STAFF REPORT

SUBJECT: [H-2023-0064](#)
Ultra Clean Franklin – MDA

LOCATION: 3070 E. Franklin Rd., in the SE 1/4 of
Section 8, T.3N., R.1E. (Parcel
#S1108449810)

C. Conceptual Landscape Plan (dated: 10/5/23)

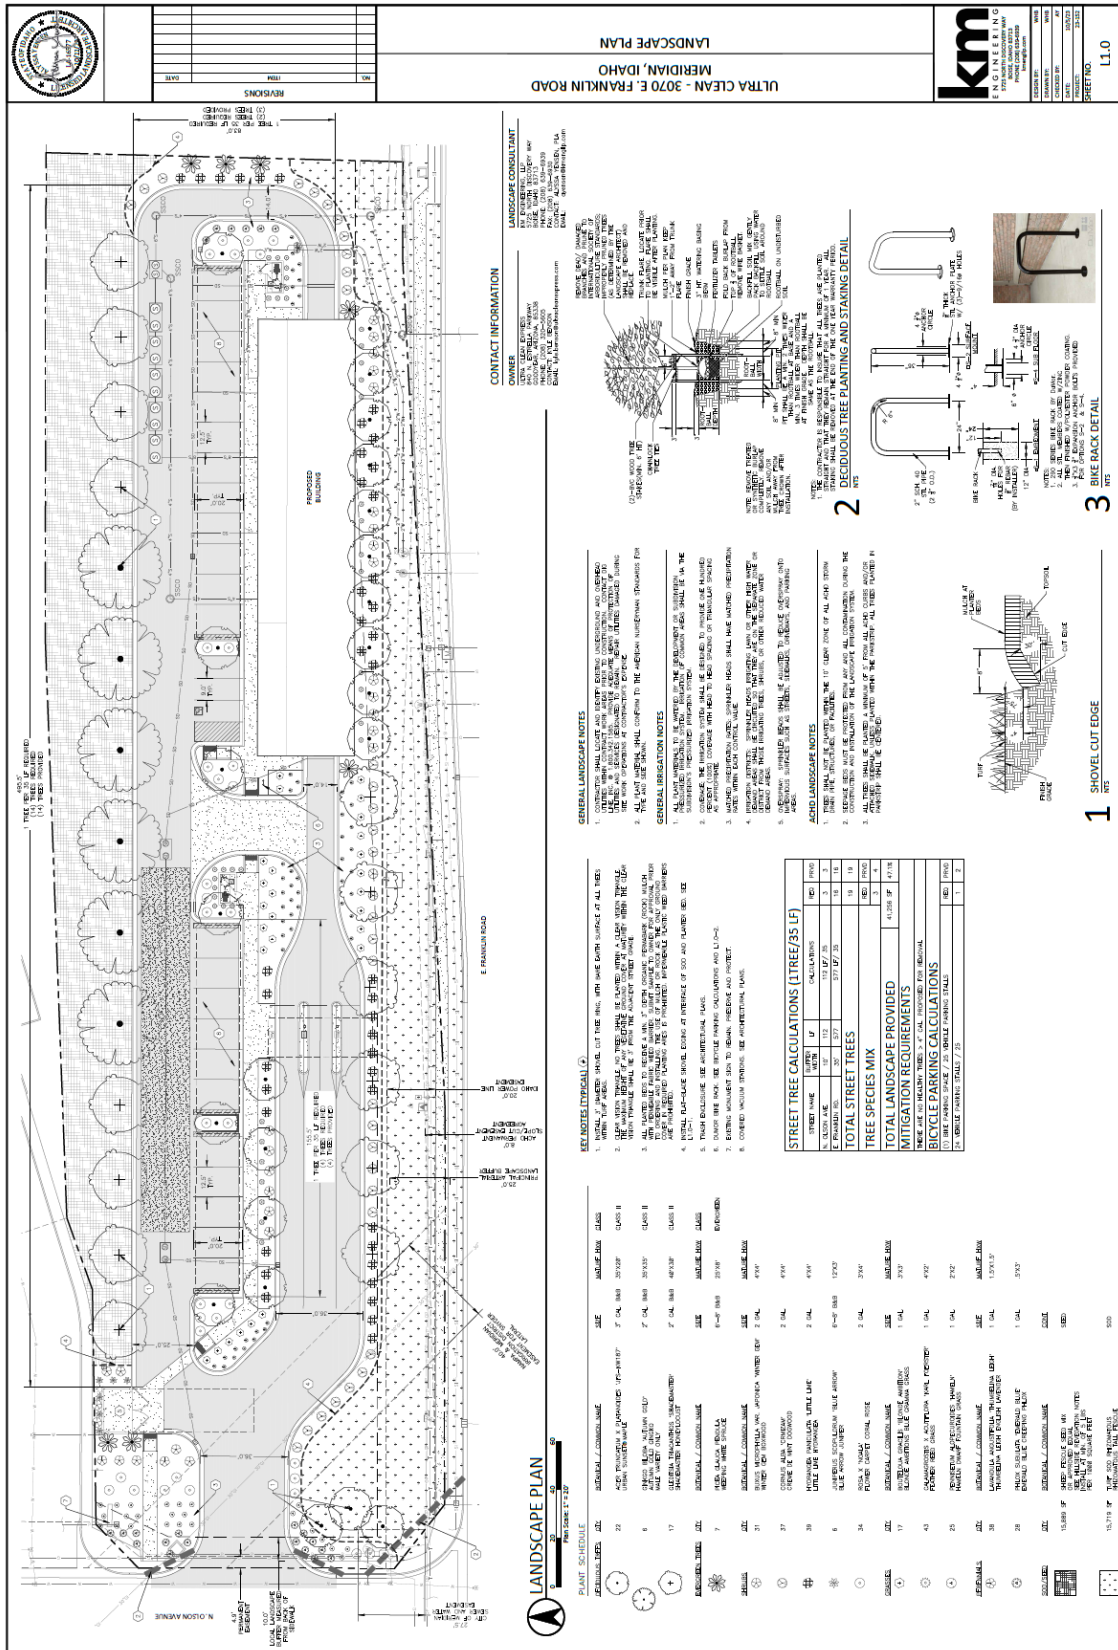
Although residential uses do not abut this site, the extended stay hotel (Waterwalk) to the north will likely be impacted by the noise from the proposed carwash and vacuums. For this reason, Staff recommends the Applicant provide dense landscaping (i.e. a mix of evergreen and deciduous trees and shrubs) that allows trees to touch within five (5) years of planting along the northern boundary of the site. The Applicant states the type of vacuums planned to be installed come with mufflers, which should assist in reducing the noise impacts to adjacent properties. To ensure mufflers are provided, Staff recommends a provision in the DA requiring such.

A 35-foot wide street buffer will be required along E. Franklin Rd., an entryway corridor (measured from ultimate back of curb location); and a 10-foot wide street buffer will be required along N. Olson Ave., a local street (measured from back of sidewalk), landscaped in accord with the standards listed in UDC [11-3B-7C](#), including enhanced landscape standards for entryway corridors. Internal parking lot and perimeter landscaping will be required per the standards listed in UDC [11-3B-8C](#).

2. Mufflers shall be installed on all vacuums to mitigate noise impacts on the abutting hotel use to the north.
3. Dense landscaping consisting of a mix of evergreen and deciduous trees and shrubs shall be provided along the northern boundary of the site that allows trees to touch within five (5) years of planting to mitigate noise from the proposed development to the hotel use on the abutting property to the north.

6. A 35-foot wide street buffer, measured from ultimate back of curb location, shall be provided along E. Franklin Rd., an entryway corridor; and a 10-foot wide street buffer, measured from back of sidewalk, shall be installed along N. Olson Ave., a local street. Landscaping shall be installed within these street buffers in accord with the standards listed in UDC 11-3B-7C, including enhanced landscape standards for entryway corridors (i.e. E. Franklin Rd.).
